**Bid 640**  
**New HVAC Modernization Project for Adolfo Camarillo High School**

**BID CLARIFICATION ADDENDUM #1**

Dated: November 20, 2020

## ATTACHMENT 2B

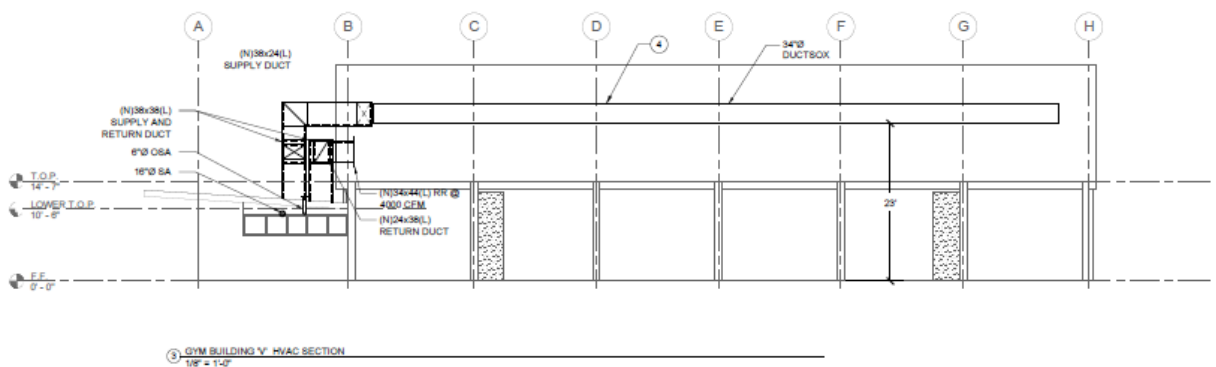
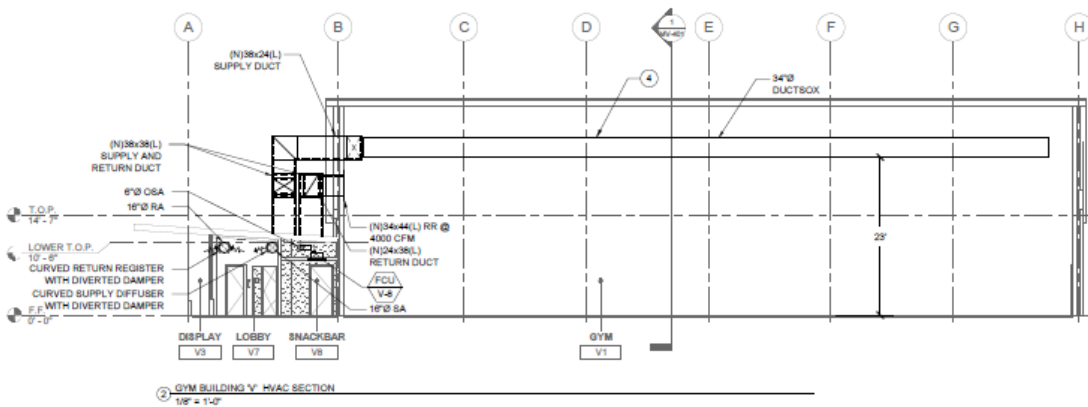
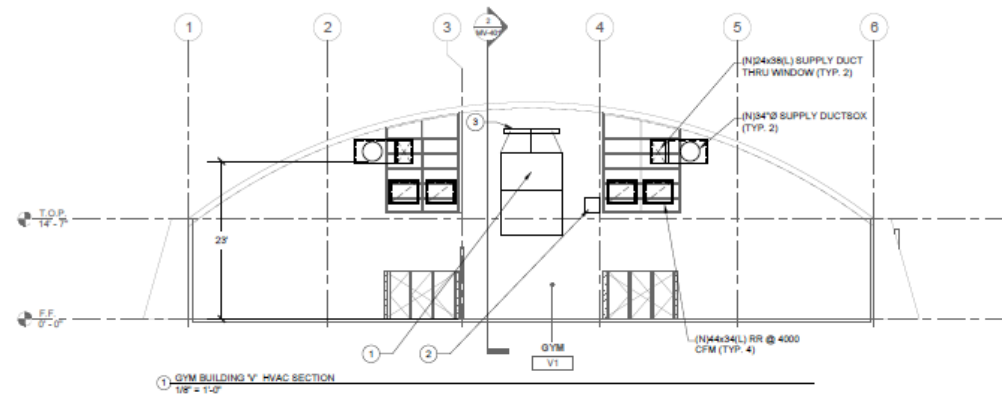
14. MD-207 – Locate Network Link on South wall of Storage D12. Provide new 120V network link with all related accessories. Provide mounting as required. See Electrical for more information.

15. MD-208 –Remove roof mounted HVAC control panel. Locate in Storage D12. See Electrical for additional information. HP/D-7 shall be 10'-0" minimum from the roof edge.

## ATTACHMENT 2B

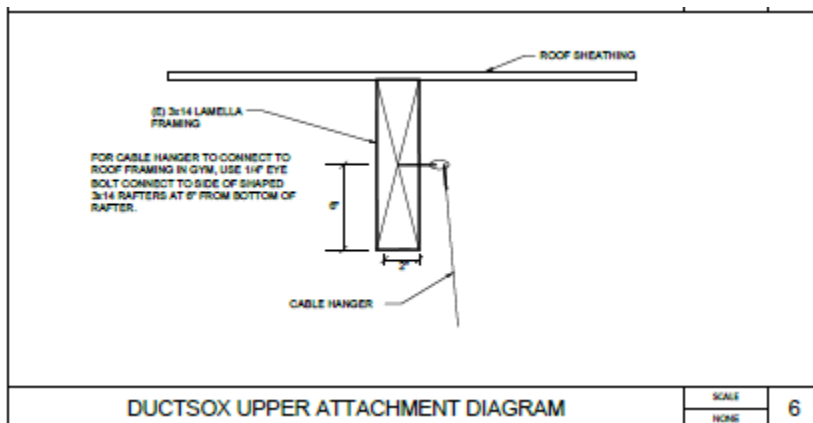
48. MW-243 – Locate Network Link and Control Panel on North wall of Mech Room W20. Provide new 120V Control Panel and new 120V Network Link with all related accessories. Provide mounting as required. See Electrical drawings for more information. Revised ducting for FCU/W-16 so the MAU air isn't connected directly to the fan coil. Revise FCU/W-5 to be wall mounted.

49. MW-244 –Remove roof mounted control panel. Locate in Mech Room W20. See Electrical for additional information.
50. MX-245 –Locate Network Link on North wall of Storage X2. Provide new 120V Network Link with all related accessories. Provide mounting as required. See Electrical drawings for more information. Move existing light conflicting with return duct drop.

## ATTACHMENT 2B

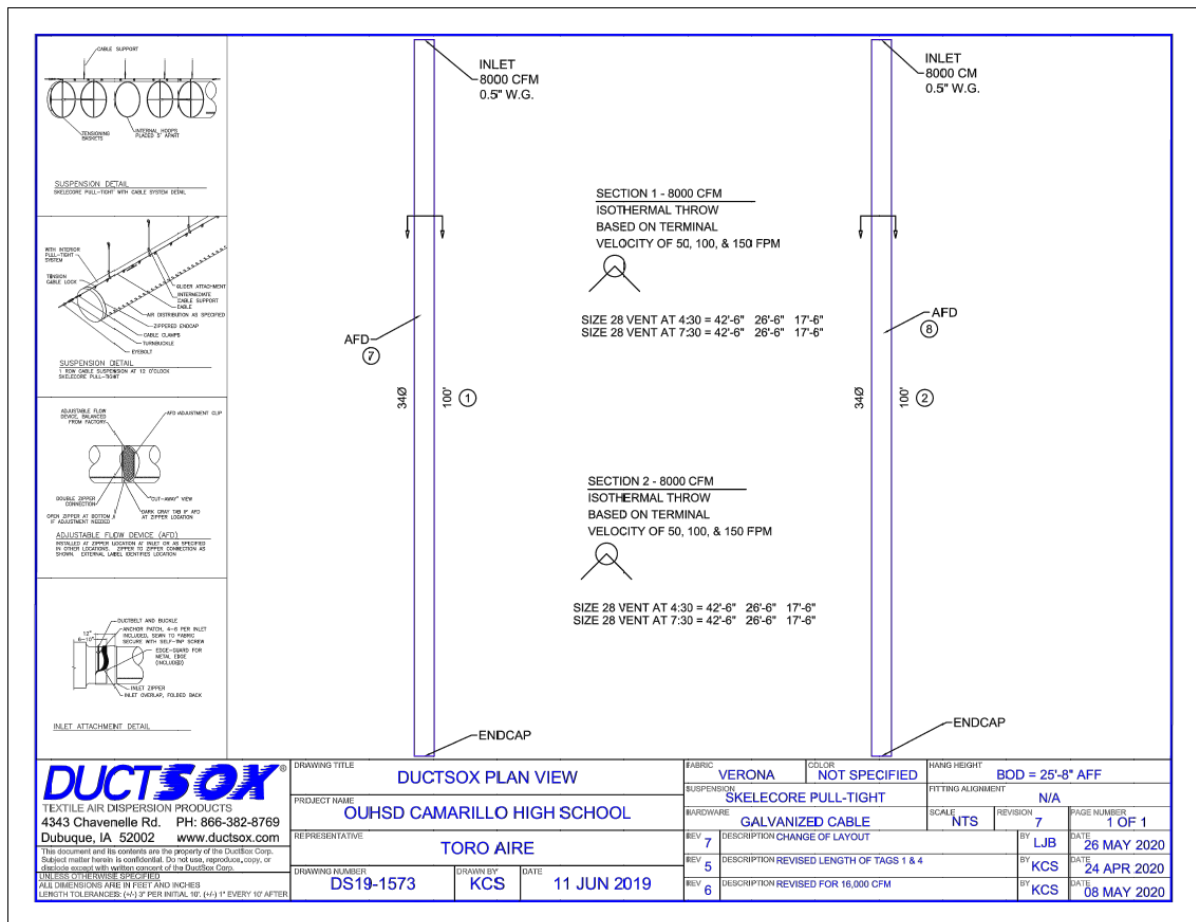
57. M-601 - ADD DUCT SOX UPPER ATTACHMENT DETAIL 6 PER STRUCTURAL.

ADD DUCT THROUGH WALL DETAIL 3.  
REVISE DUCTSOX DETAIL 1

## VERTICAL DUCT ANCHORAGE

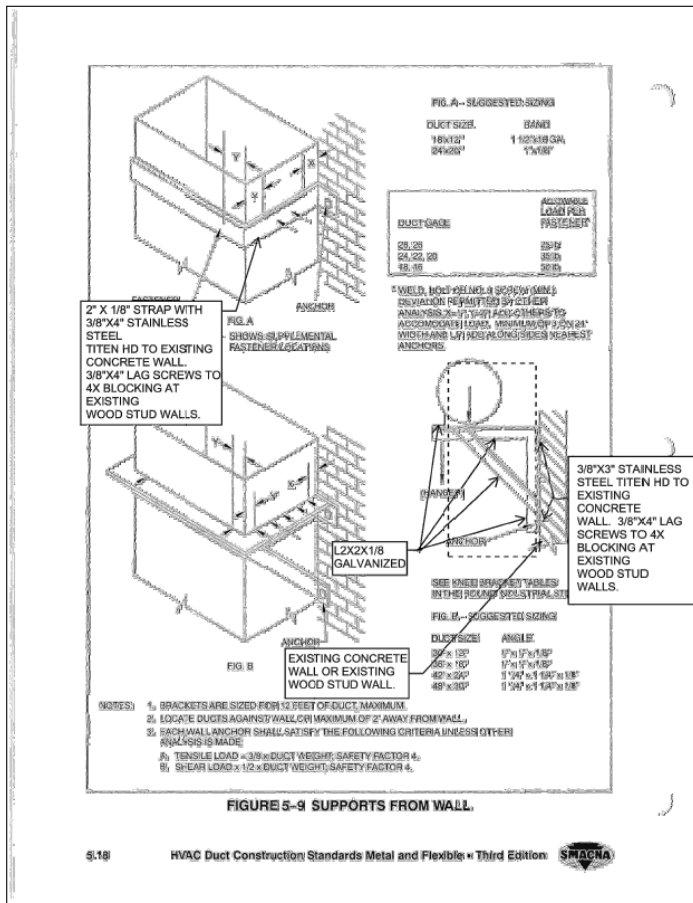
61. M-610 - DELETE CU ANCHORAGE DETAIL 4/M-610. PROVIDE 3-TON DOAS CURB BY CANFAB 1005-CB IN ITS PLACE.
62. M-612 - ADD VERTICAL DUCT ANCHORAGE DETAIL 6 PER STRUCTURAL PER SNAPSHOT BELOW.

ADDED TYPICAL HANGING DUCT SUPPORT DETAIL 7 WITH 1"X22 GA. METAL STRAPS AT 4'-0" ON CENTER FOR ROUND AND RECTANGULAR DUCTS, WITH UPPER ATTACHMENT 4/S-302 PER DSA. REMOVED DETAIL 2. PAINT DUCT SUPPORTS AND COORDINATE WITH STRUCTURAL DETAIL 12/S-303 PER DSA.

## ATTACHMENT 2B

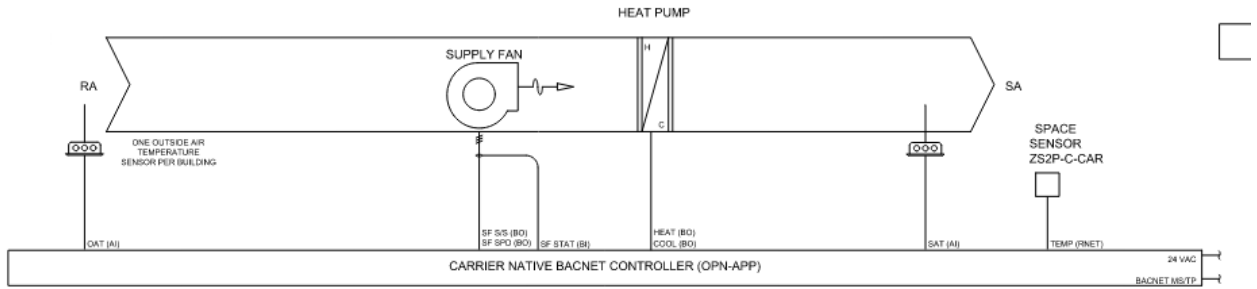
- REVISE BUILDING L CONTROLS DIAGRAM TO ADD INTERFACE KIT (24V AND BACNET 33CONNECTSTAT) FOR NEW SPLIT SYSTEM FCU/L-12, ADDED 1 CONTROL PANEL, AND ADDED CONNECTION FOR 1 EXISTING EXHAUST FAN, AND 1 NEW EXHAUST FAN.
- REVISE BUILDING K CONTROLS DIAGRAM TO ADD INTERFACE KIT (24V AND BACNET 33CONNECTSTAT) FOR 3 NEW SPLIT SYSTEMS, ADDED 1 CONTROL PANEL, AND ADDED CONNECTIONS FOR 3 EXISTING EXHAUST FANS, AND 4 NEW EXHAUST FANS.

- REVISE BUILDING J CONTROLS DIAGRAM TO ADD INTERFACE KIT (24V AND BACNET 33CONNECTSTAT) FOR 4 NEW SPLIT SYSTEMS, AND ADDED CONNECTIONS FOR 4 EXISTING EXHAUST FANS, AND 4 NEW EXHAUST FANS.
- REVISE BUILDING O CONTROLS DIAGRAM TO ADD INTERFACE KITS (24V AND BACNET 33CONNECTSTAT) FOR 4 NEW SPLIT SYSTEMS, AND ADDED CONNECTIONS FOR 3 RTU'S, AND 4 EXISTING EXHAUST FANS.
- REVISE BUILDING I CONTROLS DIAGRAM TO ADD INTERFACE KIT (24V AND BACNET 33CONNECTSTAT) FOR 3 NEW SPLIT SYSTEMS, AND ADDED CONNECTIONS FOR 2 EXISTING EXHAUST FANS.
- ADD: CONTROLS CONDUIT AND WIRING BY CONTROLS CONTRACTOR
- ADD: CONNECT ALL NEW AND EXISTING EXHAUST FANS AND MAKEUP AIR UNITS TO CONTROL PANEL. PROVIDE NEW CONTROLLERS TO FULLY CONNECT MECHANICAL EQUIPMENT TO EXISTING CARRIER IVU PRO.

④ WALL HUNG AND CASSETTE FAN COIL UNITS CONTROLS DETAIL  
SCALE : NONE

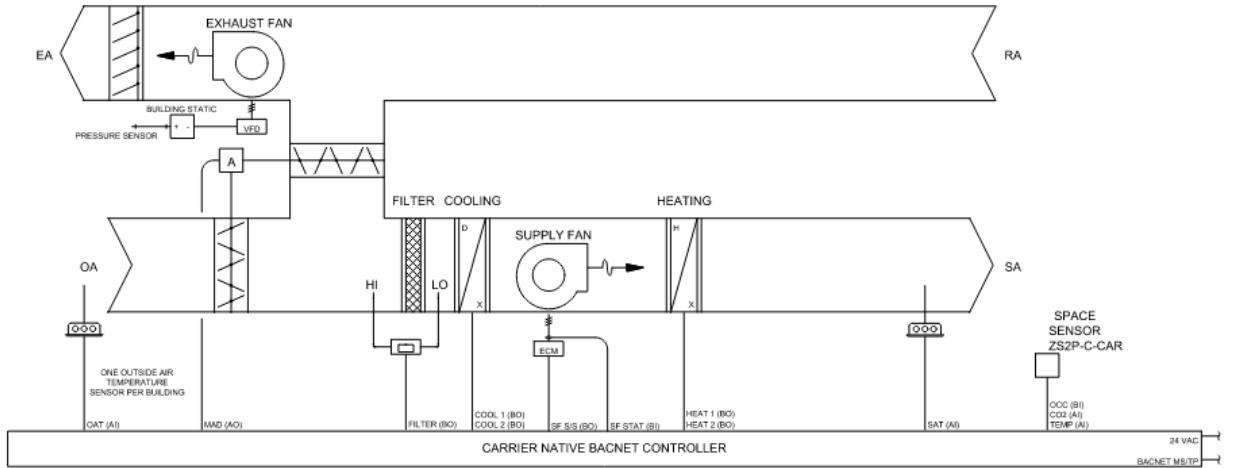
### 69. M-706 - REVISE WALL HUNG AND CASSETTE FAN COIL UNITS CONTROLS DETAIL 4. ADD 2-COOL/2-HEAT STAGED AIR COLUME ROOFTOP UNIT DETAIL 5. SEE SNAPSHOT BELOW.

③ CONTROL PANEL DETAIL (CHEMICAL HOOD CLASSROOMS)  
SCALE : NONE

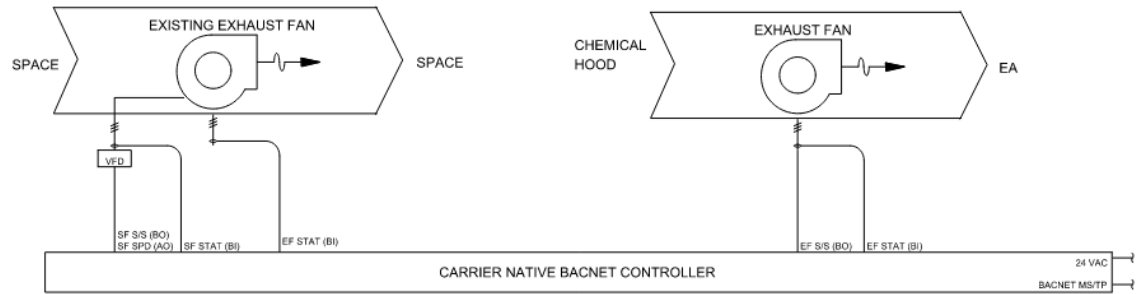
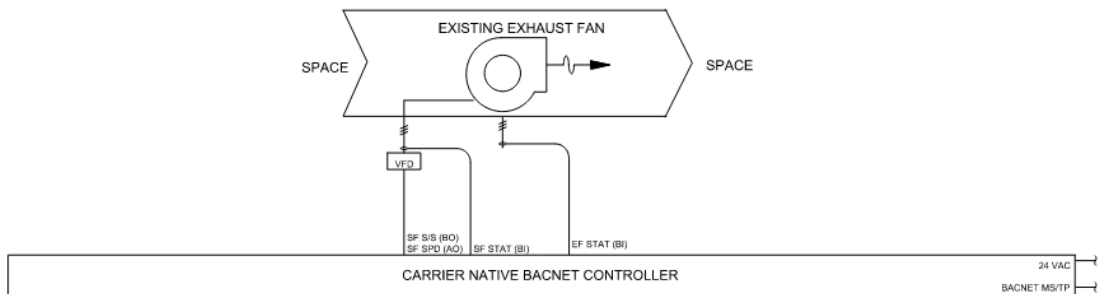
70. M-707 – ADD CHEMICAL HOOD DETAIL 3 AND EXISTING EXHAUST FAN CONTROL PANEL DETAIL  
4. SEE SNAPSHOT BELOW:

E109

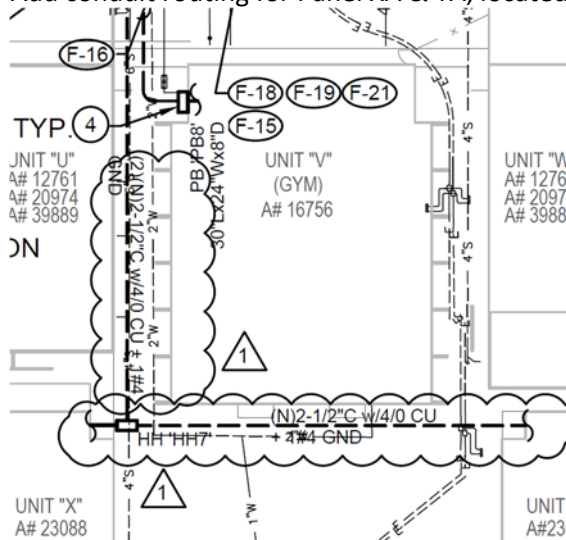
- Revise site distribution conduit routing for Building L, see below :

- Removed keynote 8 and all applicable callouts from the sheet
- Add conduit routing for Panel XA & YA, located in building X & Y, wire sizing are shown as well

E109c

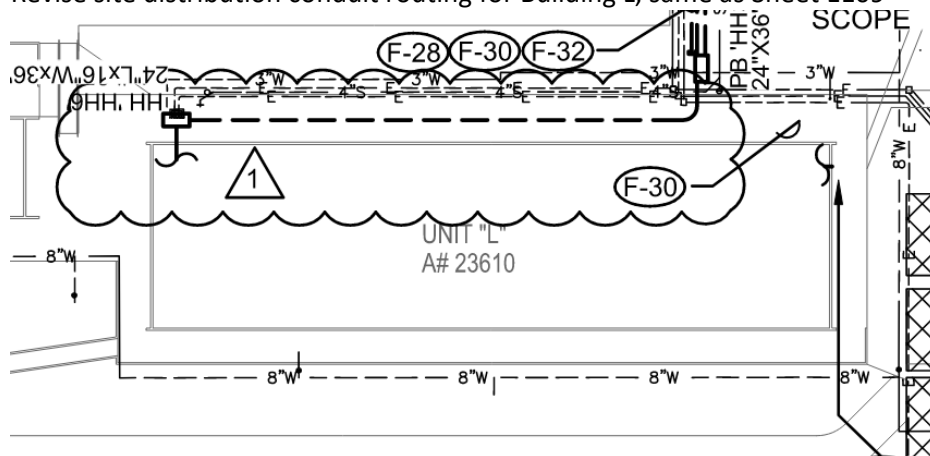
- Revise site distribution conduit routing for Building L, same as Sheet E109
